PLANNING COMMISSION STAFF REPORT

ENCLAVE CREEK – DESIGN PLAN

REQUEST: Requesting approval from the Clermont County Planning Commission for Enclave Creek – Design Plan

SHEET
1 OF 4

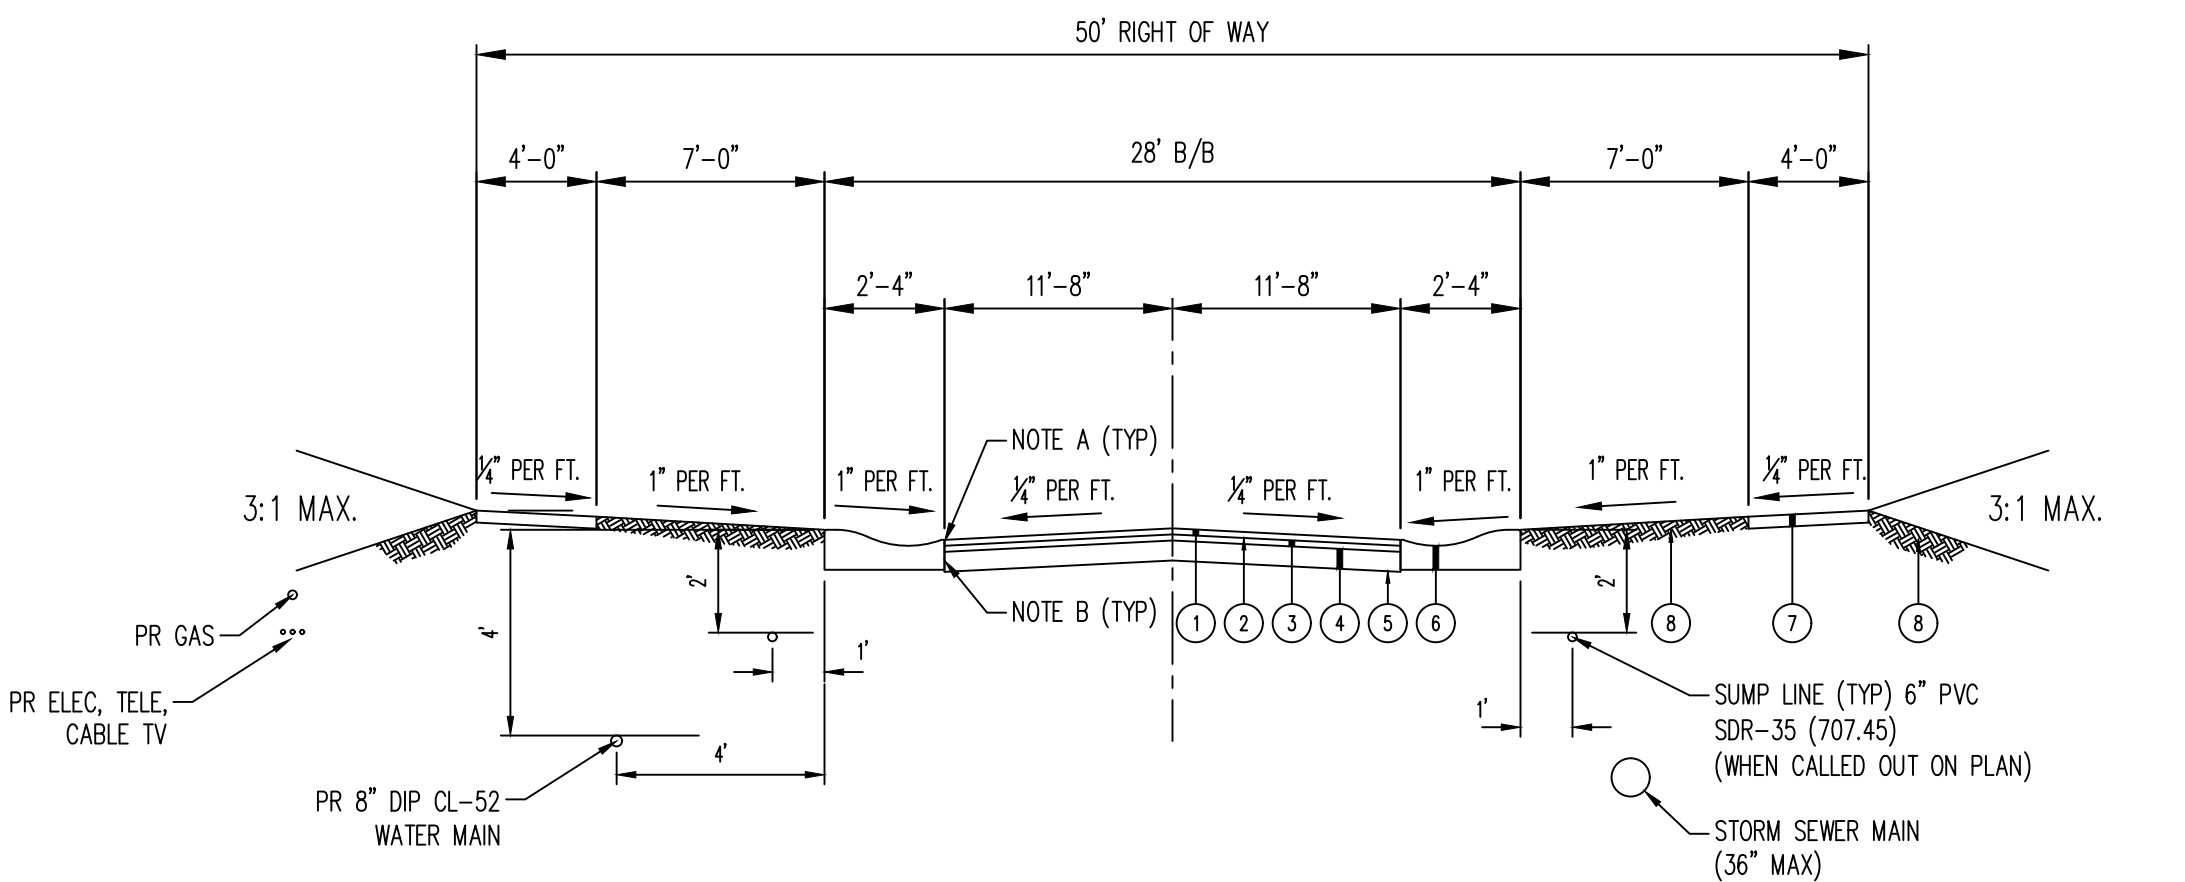
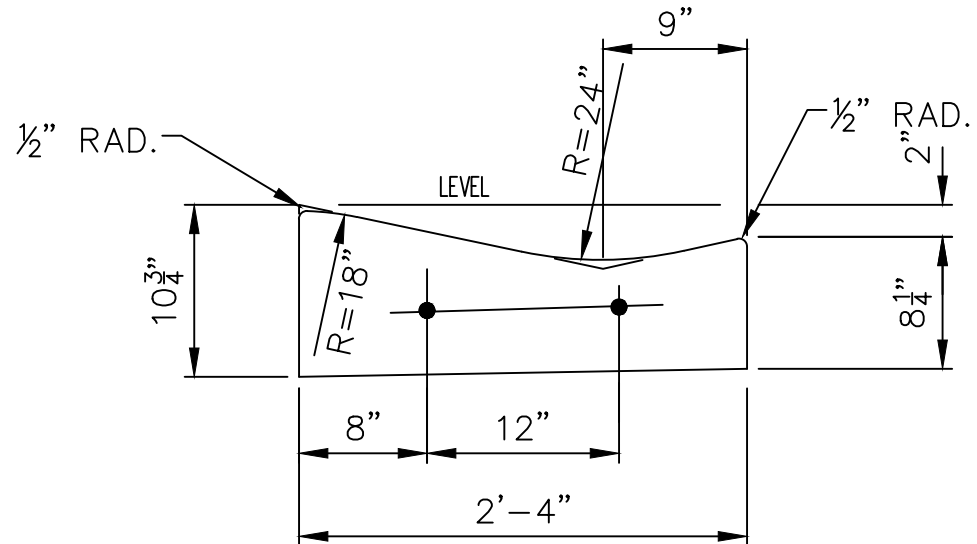
1. On Sheet 1, these drawings are not stamped by a Professional Engineer from the State of Ohio.
2. On Sheet 1, we are not the city of Springboro.

REVISIONS: 1. 2. 3. 4.	
PROJECT: 251940 DRAWING: 251940DA	SHEET 2 OF 4

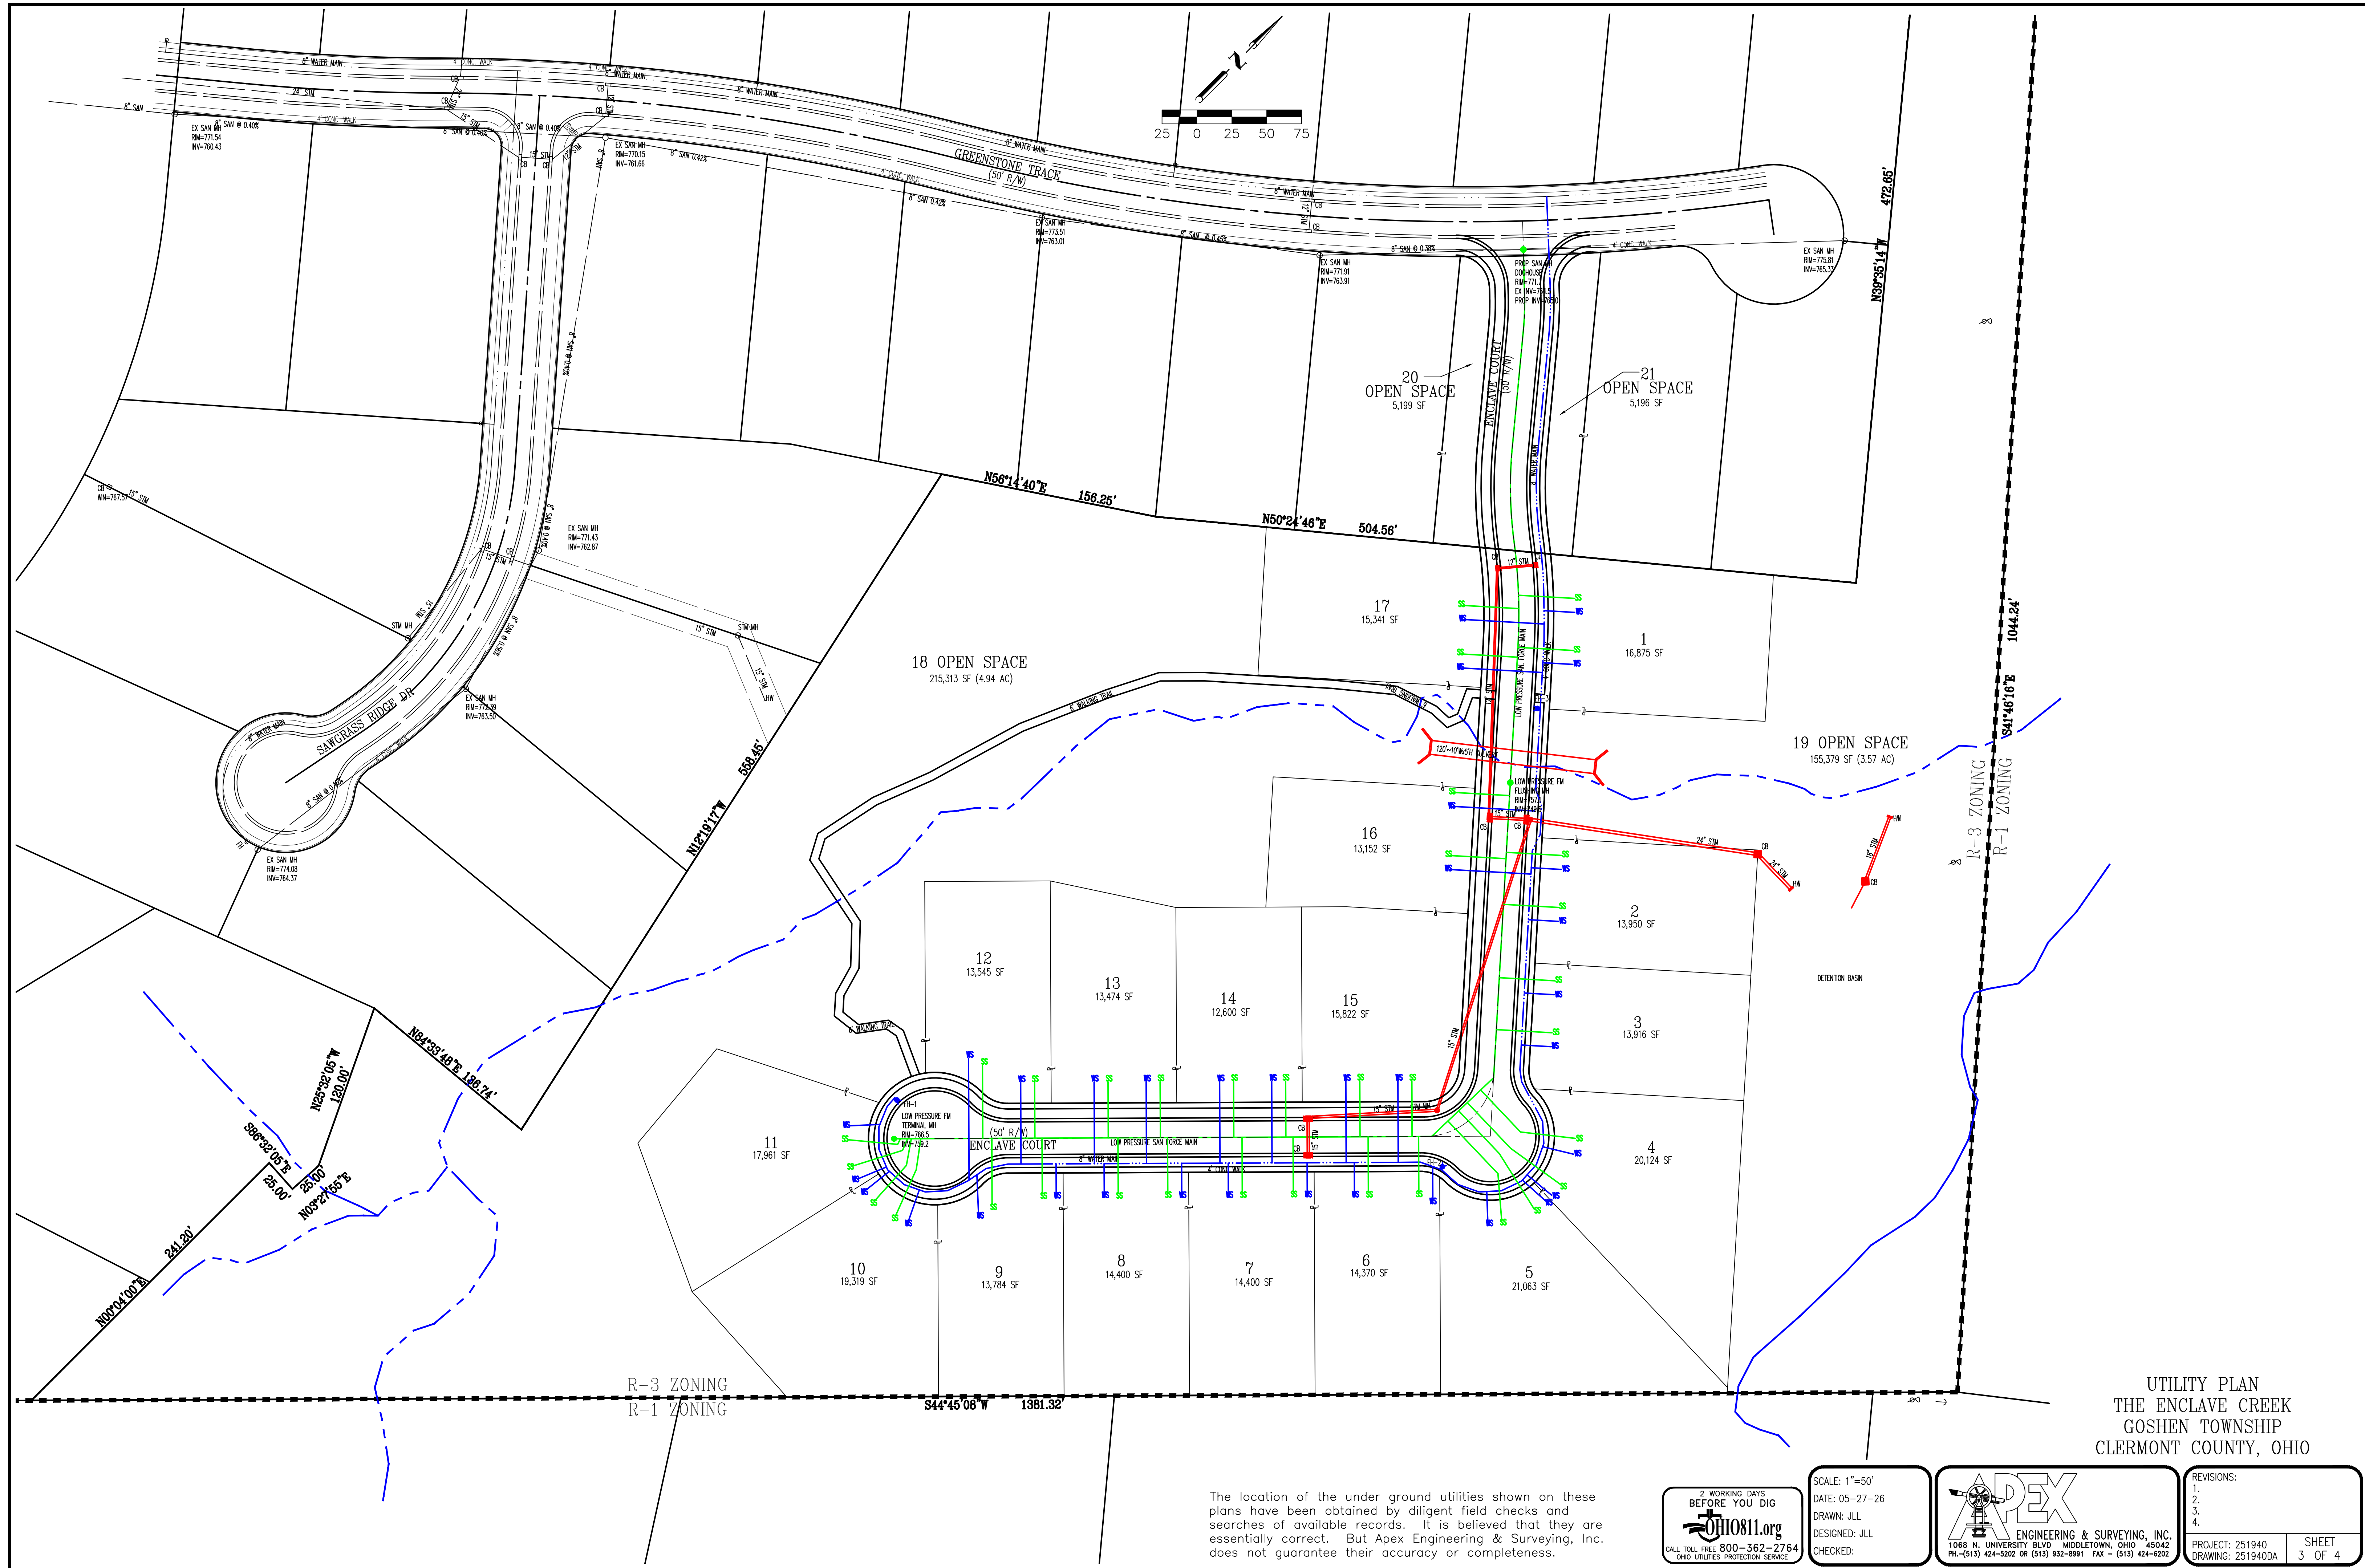
3. On sheet 2, make sure water and sewer specifications match with CCWRD standards. For example: water main separation is required to be 18 inches vertically and 10 feet vertical, no exception. Also, water main is to be tested to AWWA standards per CCWRD which is in our specifications. 150 psi testing is not up to CCWRD standards.
